REPUBLIC AVIATION CORPORATION
FARMINGDALE, LONG ISLAND, NEW YORK
• • • SERVICE DEPARTMENT • • •

No. 49

C.A.A. MANUAL AND PLACARD REVISIONS

-3 PLATE

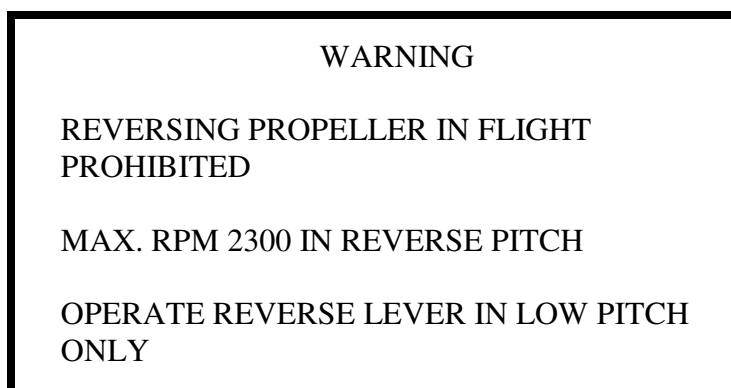
It will be noted that the revision to the manual was necessitated by the data made available to you in Service News No. 43 "propeller Counterweights." If upon inspection, it was determined that the propeller cylinder and counterweight combination with which your Seabee is equipped places the assembly into category "b" or "c" (Service News No. 43), the Operating Placard on the instrument panel will have to be changed to conform to the -3 Plate (Page 2b, revised pages of C.A.A. Flight Manual).

A reproduction of the -3 Plate is made available herewith and, where applicable, should be cut-out and pasted to the panel of the airplane to supersede the decal that was on the panel at delivery. This should be done immediately.

Note: Same as -2 plate except being applicable to airplanes with the following propeller hub and counterweight conditions:

- (a) HC-12x20-3 hubs
10” cylinder with 4.650” counterweights (2,300 RPM)
- (b) HC-12x20-3A hubs
10” cylinder with 4.50” counterweights to which have been added the 1/8” slugs (2.300 RPM)
